VT100 Mini-Term

BV4141

1. Supplement

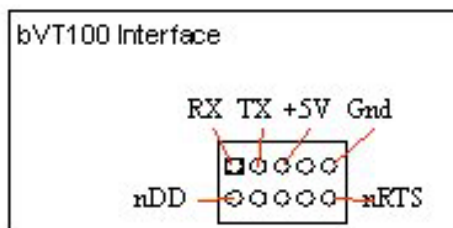
The Display is attached to the PCB with 'peelable' adhesive pads, this is to allow it to be removed or replaced for whatever reason. This can be supplemented with further adhesive if required for a more challenging environment.

The pads are positioned at the bottom of the display as show by the arrows. The adhesive is not very strong and so the display can easily be lifted.
